**DIVISION OF RATEPAYER ADVOCATES
CALIFORNIA PUBLIC UTILITIES COMMISSION**

AMENDED
**Report on the
Pipeline Safety Enhancement Plan of
Pacific Gas & Electric Company**

Pipeline Modernization Plan

R.11-02-019

Figure 13 – Results of PG&E QRA analysis for entire PSEP

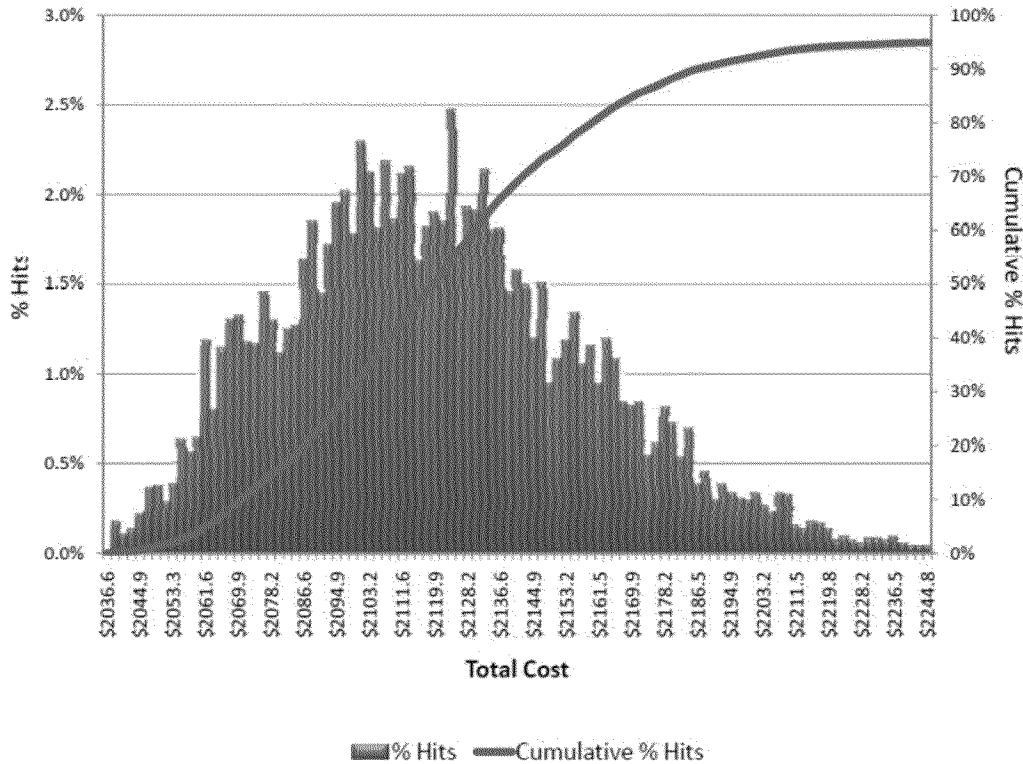
22 PG&E’s QRA analysis is best summarized by the “Cumulative % Hits”
23 versus “Total Cost” relationship shown on Figure 7-5 of PG&E’s Testimony:¹⁹⁰
24

¹⁹⁰ Figure 7-5 in PG&E’s Testimony is incorrect. See PG&E’s response to DRA data request DRA_041-07. A corrected figure was provided in the January 20, 2012 Errata filing, p. 7-42.

1 variability of outcomes over the entire “Range Applied” shown in Table 7-6, the
2 Figure 7-5 would show that there would be a probability of greater than zero (P0)
3 that actual costs will be less than the 2,036.6 million PG&E shows in Figure 7-5.
4 If PG&E were to use the AACE I Classification Range (-30% to +50%) shown in
5 Table 7-6 for Class 4 estimate, it can be argued that the P0 values should be even
6 *less* than the baseline cost of \$1,803.4 million. Given that DRA’s analysis shows
7 PG&E’s baseline cost estimate to be higher than industry averages, the QRA
8 should show a significant probability that actual costs could be lower than the
9 baseline estimate. The histogram shown in Figure 7.5 does not show distribution
10 of outcomes for actual costs on either side of the base estimate as the AACEI
11 range for a Class 4 estimate would indicate. At a minimum, the QRA should show
12 a significant probability that actual costs could be less than PG&E’s current

13 2,036.6 million estimate at P0. It appears as if PG&E tailored its assumptions for
14 the QRA model to obtain a pre-determined level of contingency for the PSEP
15 Pipeline Plan project, rather than using reasonable assumptions to let the QRA
16 model suggest a proper level of contingency.

- 1 Figure 14 - Results of PG&E QRA analysis for the replacement portion PSEP
- 2 Pipeline Plan pipeline replacement program

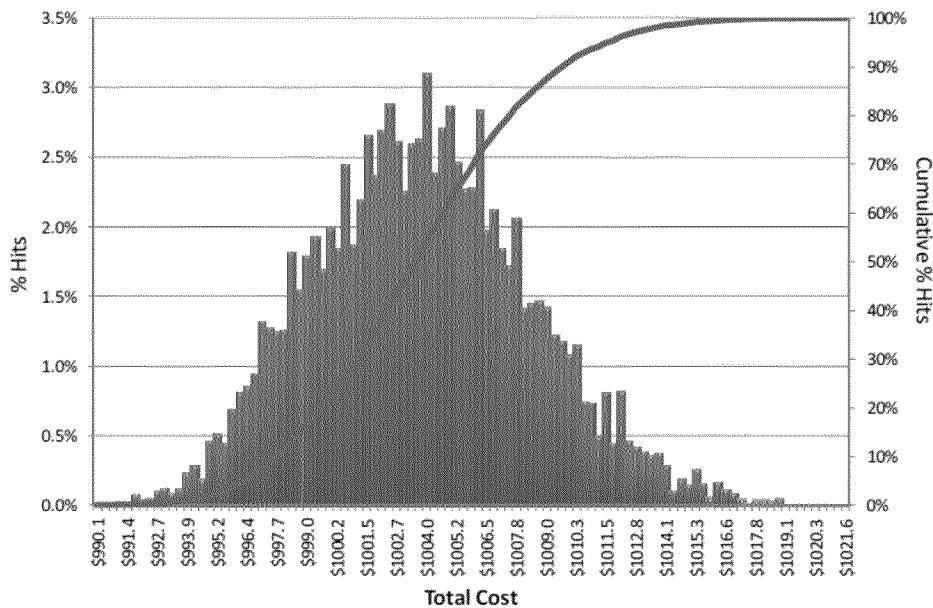
18 The following three figures illustrate the biased nature of PG&E’s QRA
19 analysis for contingency calculations of Pipeline Replacement capital projects.
20 PG&E provided the following figure in response to a DRA request to provide the
21 Monte Carlo results for pipeline capital projects:¹⁹¹

- 3
- 4 This graph makes it look as though there is a wide range of outcomes for actual
- 5 costs. However, recall that the baseline estimate for pipeline capital project,
- 6 primarily pipeline replacement, is \$928.1 million. DRA first reformatted the
- 7 above data to show the Monte Carlo results for pipeline capital projects the 20%
- 8 contingency used by PG&E, and PG&E's P90 value:¹⁹²
- 9

1 Figure 15 – PSEP Contingency request for pipeline replacement compared to
 2 PG&E QRA results¹⁹³

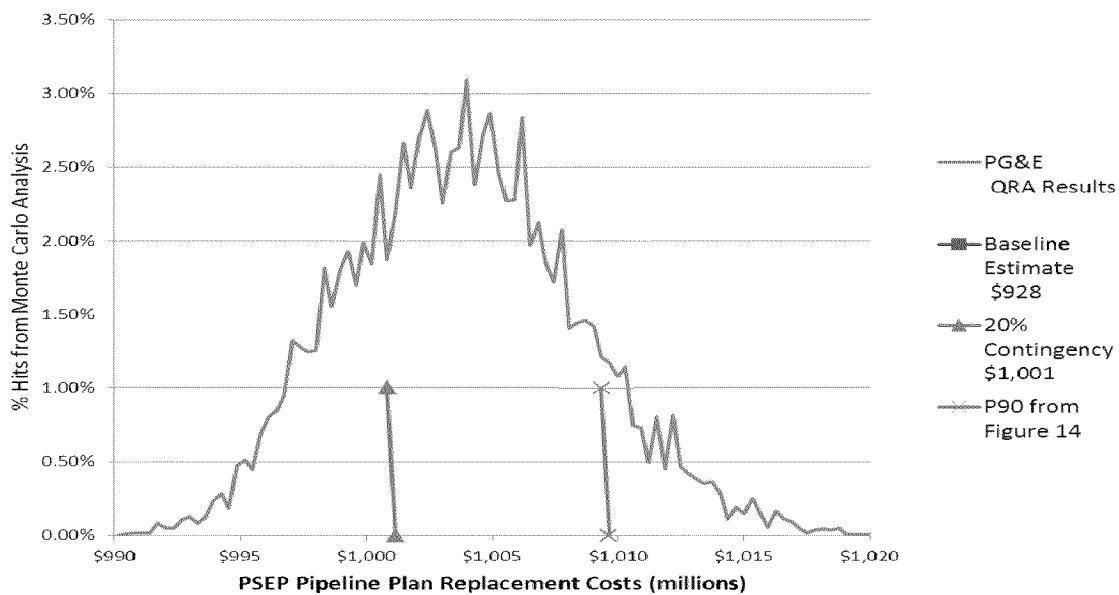
5 Figure 15 illustrates that PG&E’s QRA provides outcomes roughly
 6 centered on the 20% value chosen by PG&E, but skewed to the right (greater
 7 probability of higher cost). This figure also illustrates the discrepancy mentioned
 8 in footnote XXX of this exhibit, since PG&E’s 20% contingency is supposed to be
 9 a P90 value. It is clear from this figure that the 20% contingency is not a P90
 10 value.
